GULMOHAR RESIDENCY

Details of Additions & Alterations

Flat No	605	Block no.	'H'
Flat Area	1360 sq ft	Type	Deluxe / Luxury
Buyer Name	Mr. Satish Kumar.K		
Phone No.	9866317766	Email	Satish.9618869455@gmail.com

Description	Direction	Owners & Developers :	Date :	16.09.20	Promoted by
PLUMBING PLAN-1360 Sft (A1-TYPE)		Modi Reality Mallapur LLP	Prepared By :	Jayapradha	Modi Properties Pvt Ltd
		Project Name & Phase :	Approved By :	Soham Modi	
		Gulmohar Residency	Scale :	N T S	Phone: +91-40-66335551

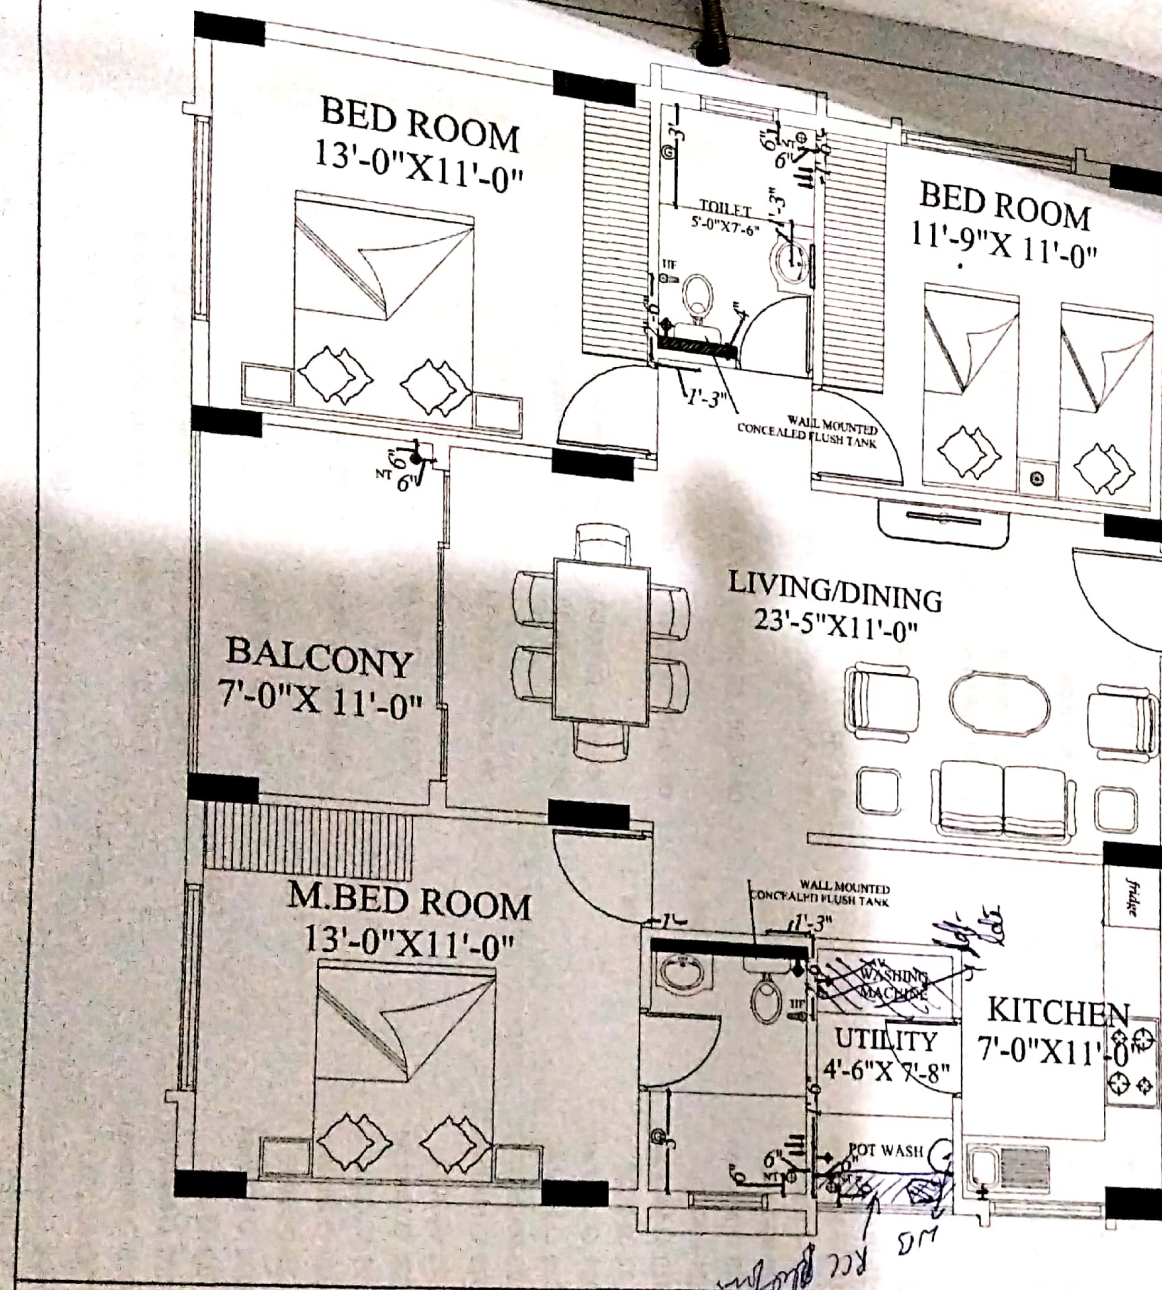
Changes in electrical points: (mark on plan)

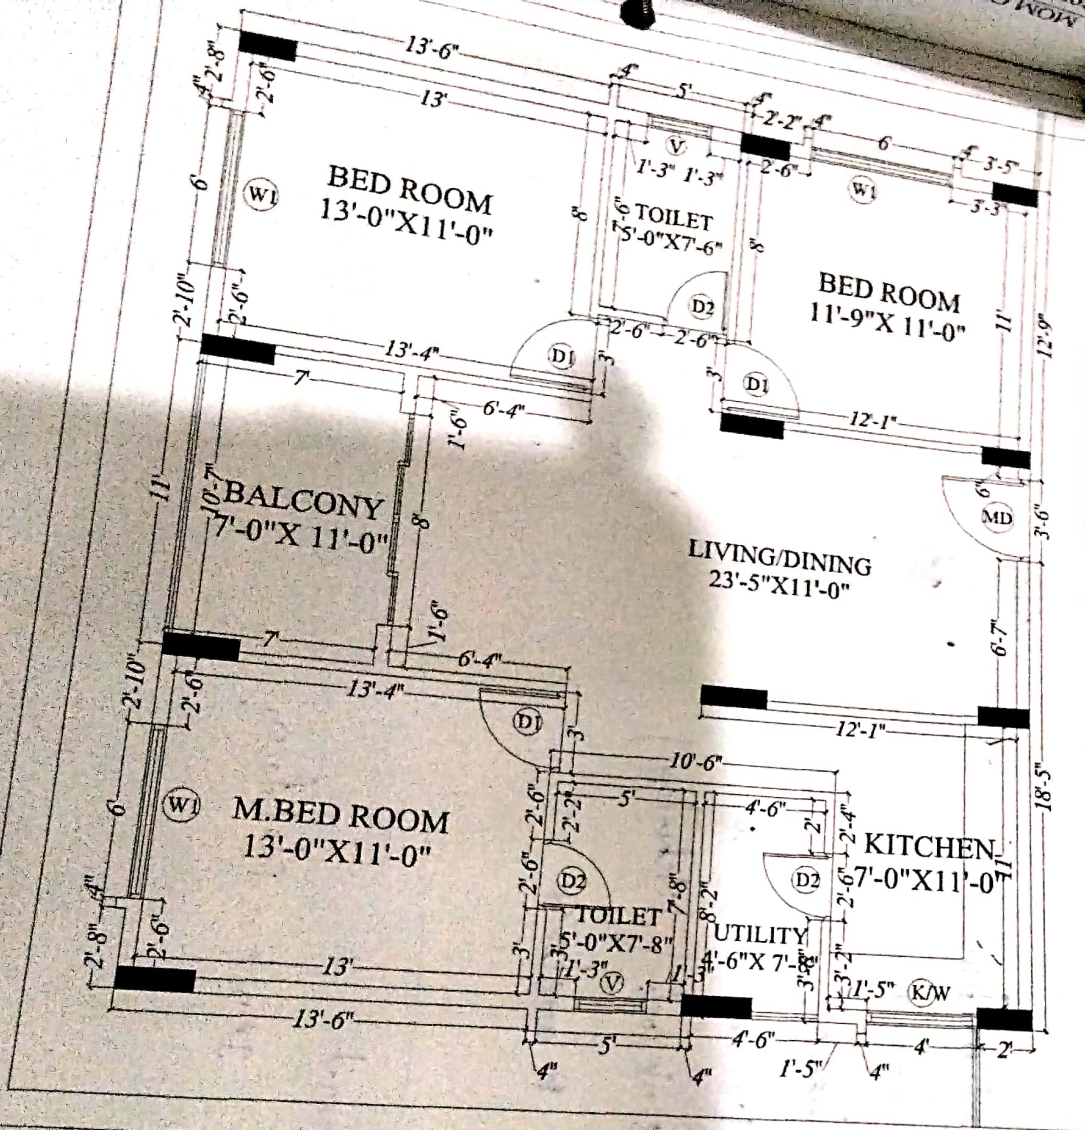
Changes in kitchen platform: (mark on plan)

- (1) Sink position to single corner in kitchen.
- (2) Plug connection for chimney - exhaust system.
- (3) Cabinet top after installation (middle kitchen).

Other Changes:

- (1) CT → Door changing
- (2) Balcony → into extra part.
